City of Mississauga Department Comments

Date Finalized: 2024-08-16	File(s): A344.24
To: Committee of Adjustment	Ward: 5
From: Committee of Adjustment Coordinator	Meeting date:2024-08-22 1:00:00 PM

Property Address: 165 Preston Meadow Ave

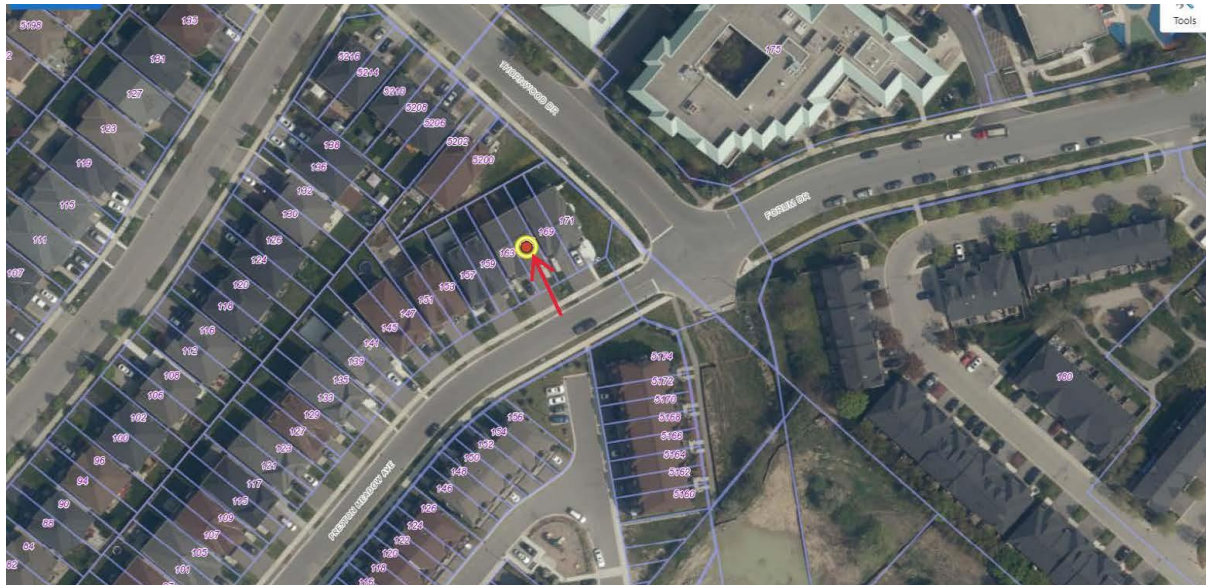
Planning staff note the site plan provided does not depict the existing condition of the driveway, as the extension of the driveway width (as seen on the site plan) should align with the stairs leading to the front entryway of the dwelling. As seen in the photos provided below, the driveway width extends past the front stairs right to the abutting side lot line. An additional variance may be required for a driveway setback of 0.6m (1.96ft). Additionally, Transportation & Works staff have noted concerns regarding the required 1.5m (4.92ft) separation distance between the existing hydro transformer and driveway on the front yard. Staff note the extension of the current driveway is right up against the hydro transformer. While staff do not have concerns with the proposed 6m (19.68ft) driveway width, staff are recommending a deferral of the application for the opportunity to redesign the driveway to alleviate Transportation & Work's staff concerns and ensure all variances are identified correctly.

From the enclosed photos we note that the applicant has widened the concrete driveway right up to the existing hydro transformer with concrete which creates a number of concerns. First it should be noted that any driveway is to be a minimum of 1.5m away from any utility, in particular the hydro transformer. Secondly, in the event that any maintenance is required to the hydro transformer or the electrical cables underground, the concrete area would have to be removed resulting in extra unnecessary costs.

In view of the above we would request that any approval of the widened driveway would have to at least provide a 1.5m separation to the hydro transformer and this portion of the municipal boulevard be re-instated with topsoil and sod.
